# Planning Commission Staff Report

**Subject:** Treasure  
**Project #:** PL-08-00370  
**Authors:** Francisco Astorga, AICP, Senior Planner  
**Date:** 29 November 2017  
**Type of Item:** Administrative – Conditional Use Permit Refinement 17.2

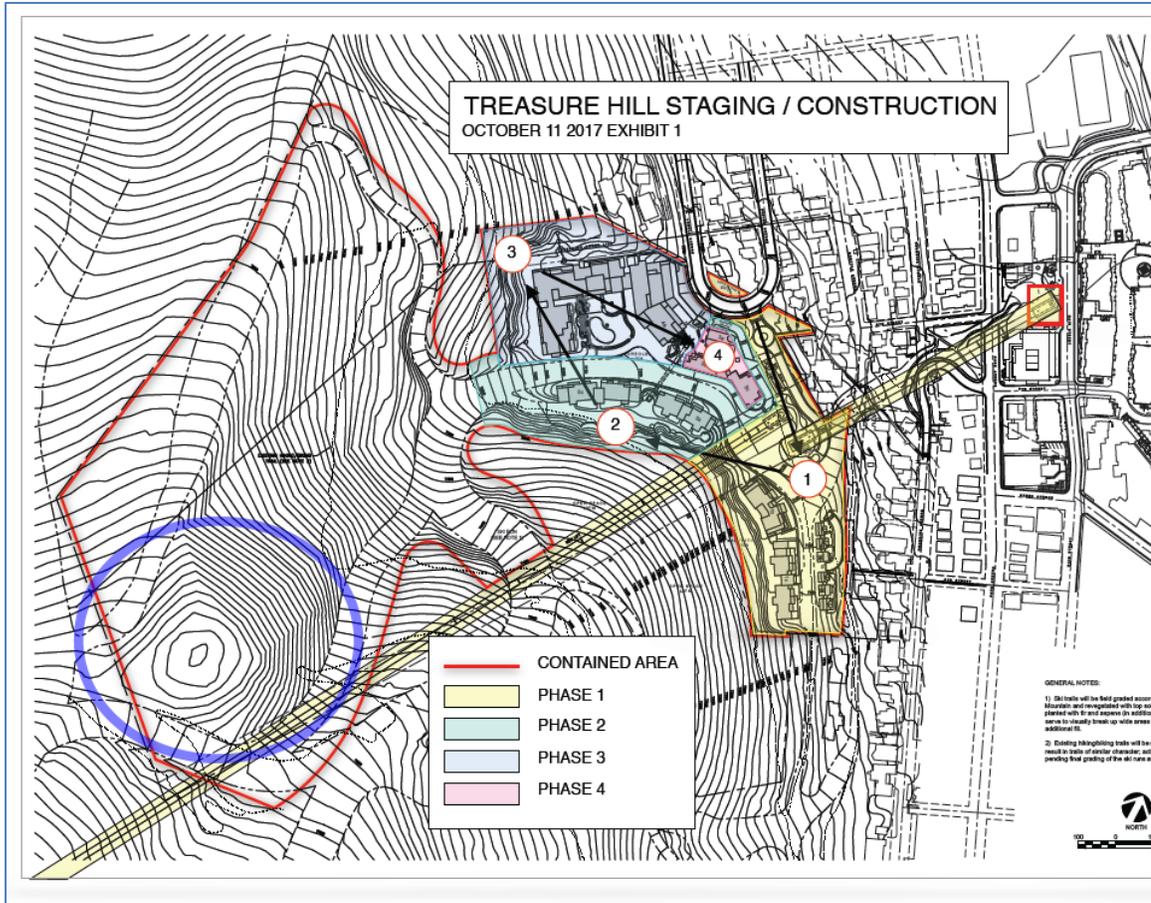
- 2. Limit of Disturbance / Building Area Boundary / Development Boundary**  
During the November 8, 2017 Planning Commission meeting, the applicant indicated that their proposed Limit of Disturbance would be approximately where the contained area, red boundary, shown on the [October 11, 2017 Applicant Presentation](#) (Exhibit 2,4, and 5). The same exhibit is shown below with a yellow outline showing the Building Area Boundary / Development Boundary as shown on the Master Plan.

As indicated during the November 8, 2017 Planning Commission meeting Staff finds that the Limit of Disturbance needs to be within the Building Area Boundary / Development Boundary and not vice versa. When reviewing the Master Plan Sheets, the Hillside Properties (Town Lift Mid-Station and Creole-Gulch sites), were the only sites that had a Building Area Boundary / Development Boundary shown on the Master Plan, which is consistent with the area that would later be re-zoned to Recreation and Open Space (ROS) District, as required by the Master Plan approval.

**Does the Planning Commission agree with staff that the proposal would be in compliance with the 1985/1986 Master Plan if the proposed Limit of Disturbance of the 2004 Conditional Use Permit is placed within the Building Area Boundary / Development Boundary?**

2009 TREASURE CUP

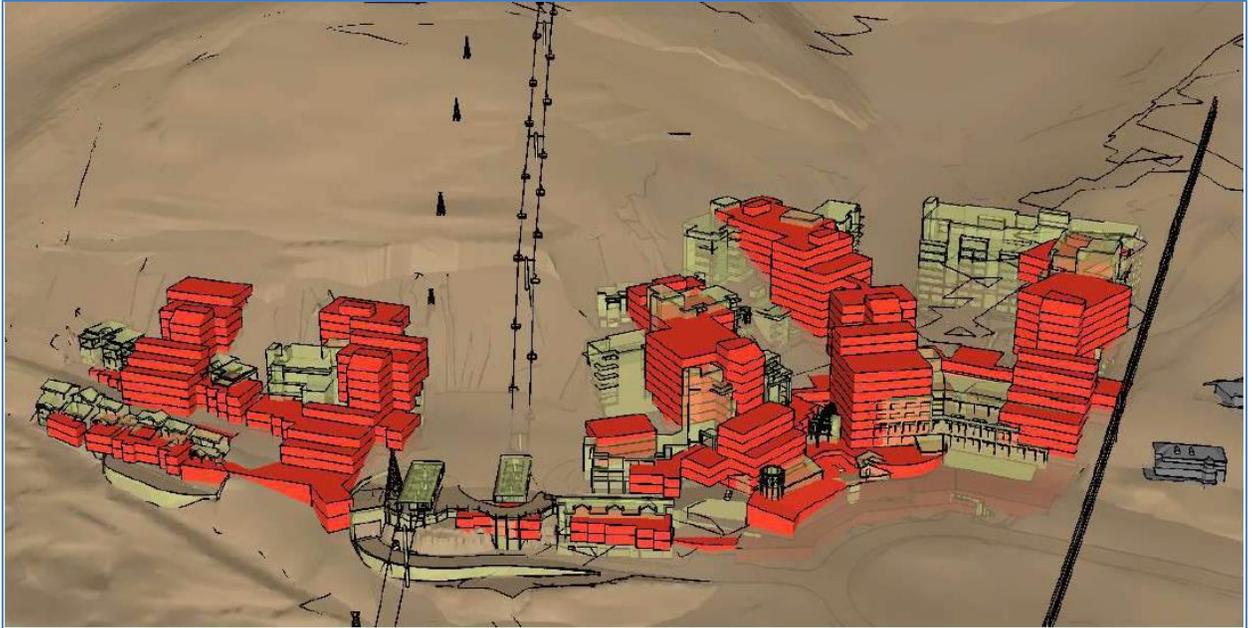
The 1986 volumetrics of the concept plan provided a visual representation of how the rear of the five (5) major building wings (consistent with each building sections) did not have the substantial excavation as shown in the 2009 plans and also the Refinement 17.2. Staff recognizes the Master Plan shows significant massing at Creole-Gulch site somewhat close to the road. Staff reiterates that needed articulation is a function of the Conditional Use review process.

**Due to the excavation of the proposal throughout the entire project demonstrated in Refinement 2009 and 17.2 that significantly lowers final grade from its original location, creates a lack of consistency with the master plan with the exception found above. It needs to be noted that the applicant has not submitted the same comparison of Refinement 17.2 and the Master Plan volumetrics. If the applicant can demonstrate similarity with the master plan, consistency with the master plan can be accomplished while at the same time mitigating impacts associated with building mass / bulk and physical design and compatibility with surrounding structures. Does the Planning Commission agree with this analysis?**
